Office Action Summary	Application No. 10/669,273	Applicant(s) FREDETTE, STEVEN J. S10	
	Examiner Melissa Austin	Art Unit 1745

DETAILED ACTION

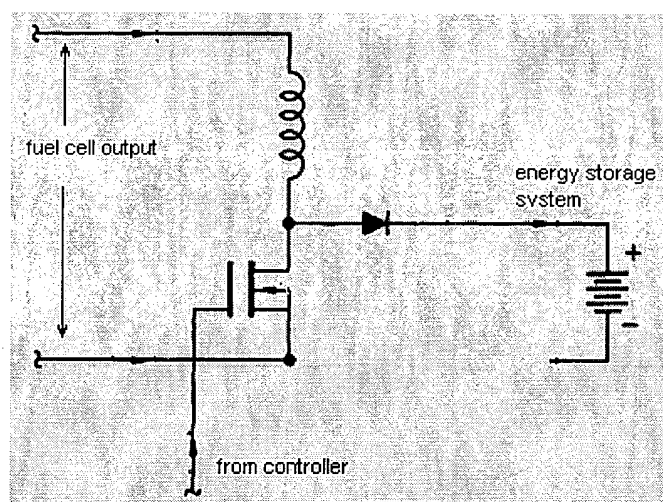
7. Claim 3 is rejected under 35 U.S.C. 112, first paragraph, as failing to comply with the enablement requirement. The claim(s) contains subject matter which was not described in the specification in such a way as to enable one skilled in the art to which it pertains, or with which it is most nearly connected, to make and/or use the invention. The reading of claim 3 results in the following circuit schematic:

Applicant's specification does not enable one of ordinary skill in the art to make or use the invention of instant claim 3. The specification is enabling for the invention of instant claim 2, where the circuit is the same as the schematic above except that the negative terminal of the energy storage system and the lower fuel cell output are connected. The specification includes no description of the embodiment of instant claim 3 or how it may be made or used for storage of energy from a fuel cell. This rejection may not be overcome by amending the specification to include the embodiment of instant claim 3 because the instant claim is not an original claim, and, as such, would constitute new matter in the specification.
